Project  
**THE WEST MIDLANDS RAIL FREIGHT INTERCHANGE ORDER 201X**

Drawing Title  
**ACCESS AND RIGHTS OF WAY PLAN SHEET 1**

Regulation 5 (2) (k)	Document 2.3A
Drawn NW Date: JUNE 2018 Scale 1: 2500	Reviewed JF Rev G

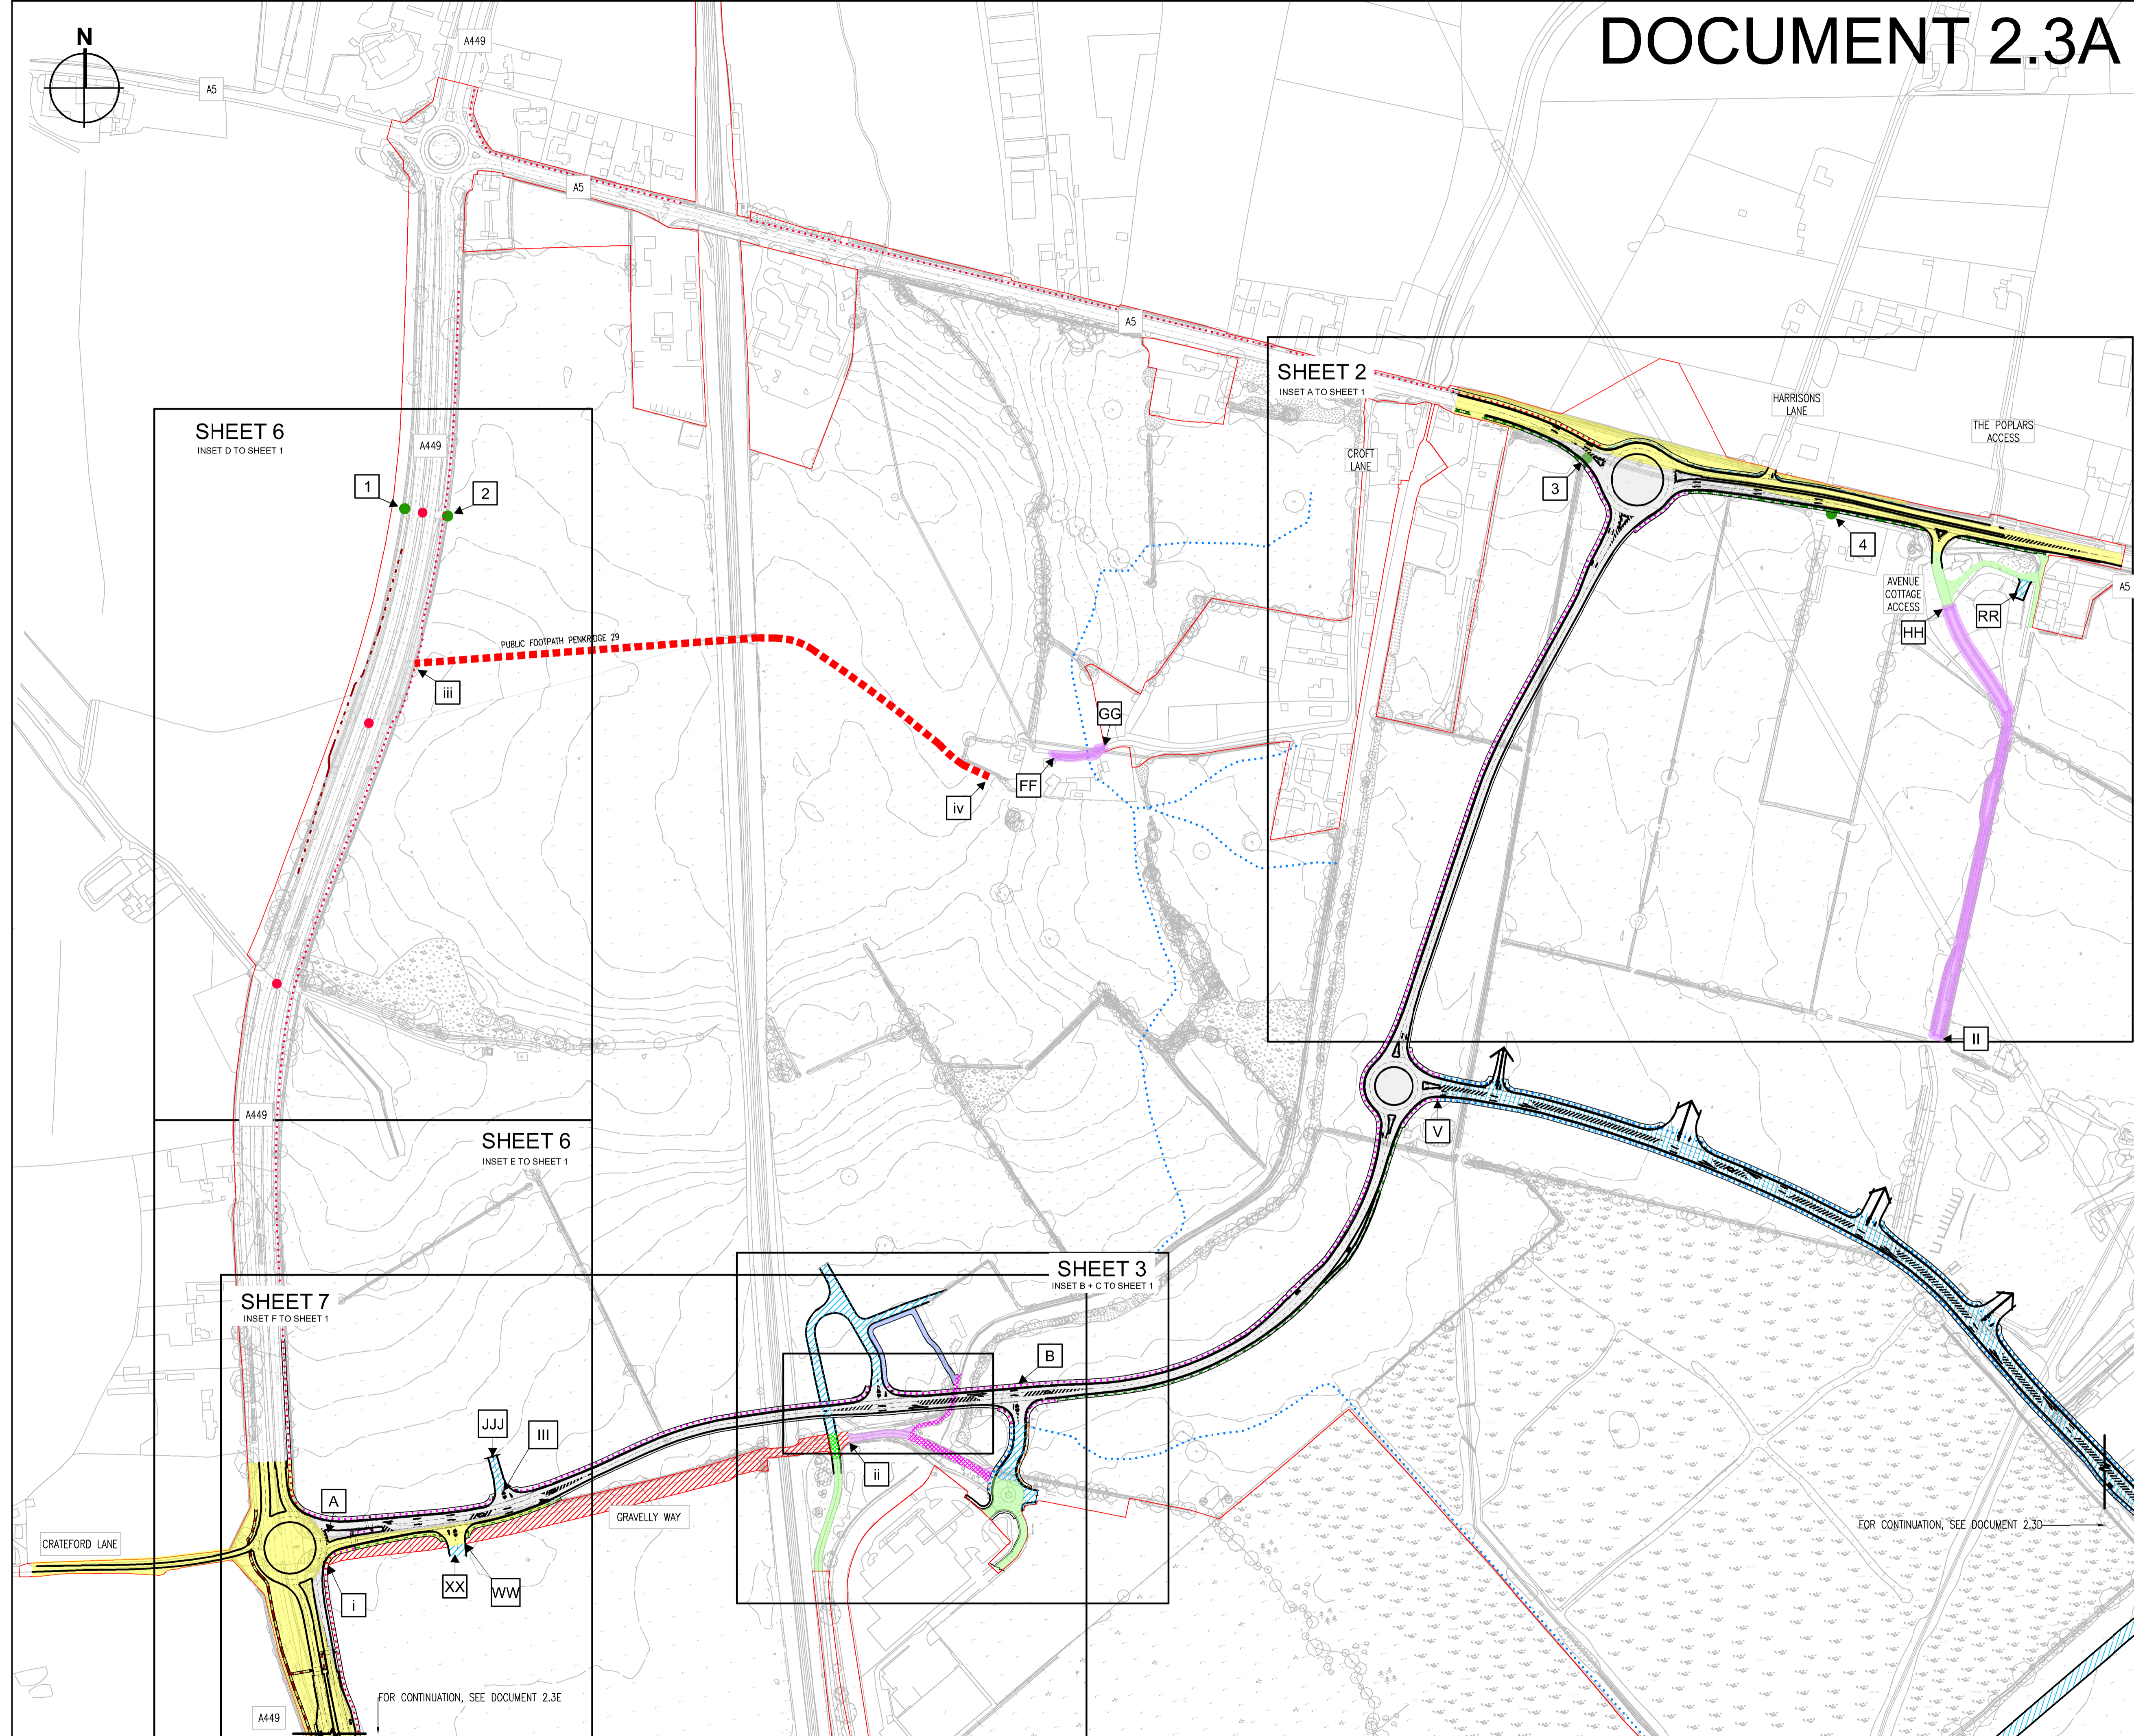
- PEDESTRIAN CROSSING ON THE A449 SIGNALISED AND RELOCATED FURTHER SOUTH OF THE ROUNDABOUT IN RESPONSE TO COMMENTS FROM HIGHWAYS ENGLAND IN RSA.
  - PEDESTRIAN CROSSING ON GRAVELLY WAY MOVED EAST, STAGGERED AND SIGNALISED IN RESPONSE TO COMMENTS FROM HIGHWAYS ENGLAND IN RSA AND AS A RESULT, THE ACCESS TO THE TAIL TERMINAL HAS BEEN MOVED EAST. THE TOTAL WIDTH OF THE GRAVELLY WAY ARM HAS BEEN INCREASED TO PROVIDE SUFFICIENT WIDTH FOR THE CROSSING AND VEHICLE MOVEMENTS.

- FOOTWAY WEST OF THE A449 HAS BEEN RELOCATED AND RECLASSIFIED AS CYCLEWAY / FOOTWAY IN RESPONSE TO COMMENTS FROM HIGHWAYS ENGLAND IN THE RSA.
  - ADDITIONAL VERGE ON THE EASTERN SIDE OF THE A449 HAS BEEN ALLOCATED TO ENSURE VISIBILITY TO THE PEDESTRIAN CROSSINGS IS PROTECTED.

- JULY 2019
- LABELS REMOVED TO REFLECT SCC REQUEST THAT CERTAIN FOOTWAYS / CYCLEWAYS ARE NOT IDENTIFIED AS NEW PUBLIC RIGHTS OF WAY.
  - PEDESTRIAN CROSSING OF WESTBURN GRAVELLY WAY POSITIONED FURTHER WEST IN RESPONSE TO HIGHWAYS ENGLAND COMMENTS AND RSA.

- CROSSING AREA ON CENTRAL ISLAND OF GRAVELLY WAY REVISED.
